# Memorandum

**Re:** DFT Final Sign-Off NDBP Aquatic Center PR 2023-008180

## **CONDITIONS OF APPROVAL – SI 2024–00062 – DFT Final Sign-Off**

## SITE PLAN - EPC

**A1 SITE PLAN**  
1" = 30'-0"

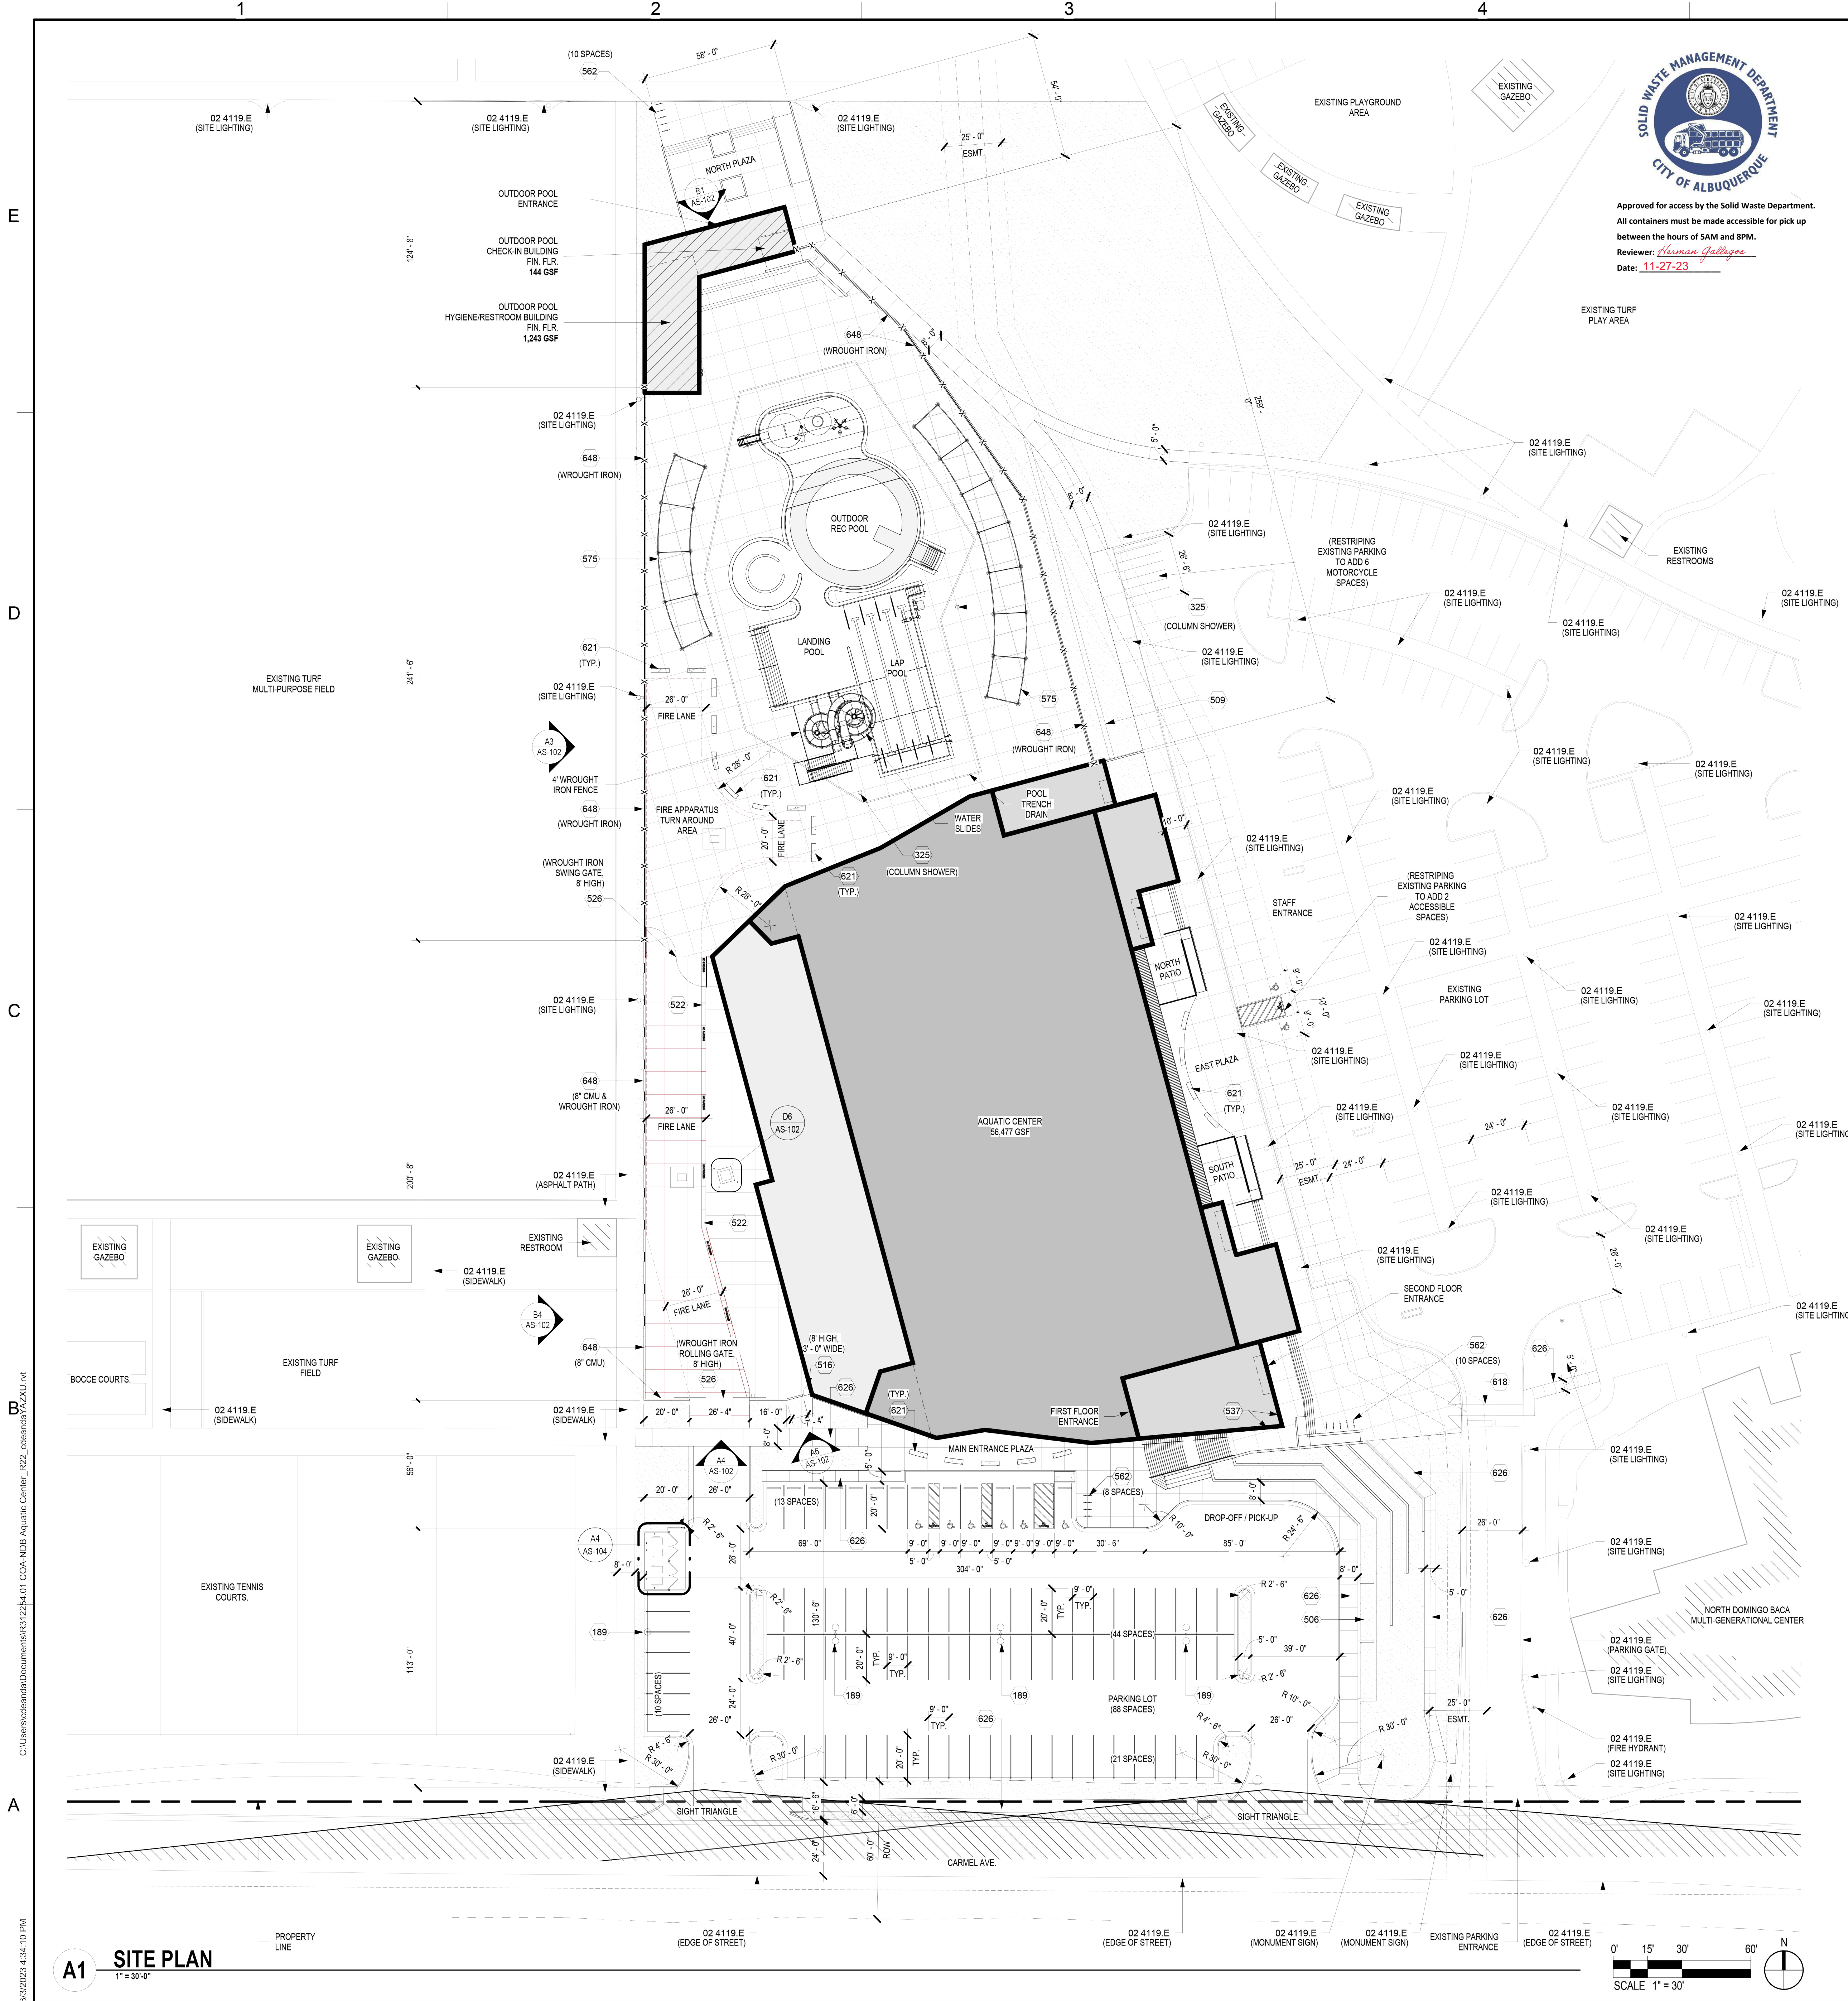
1. The project and application numbers must be added to the Site Plan top sheet.

*Applicant Response: The project and application numbers have been added to the Site Plan top sheet.*
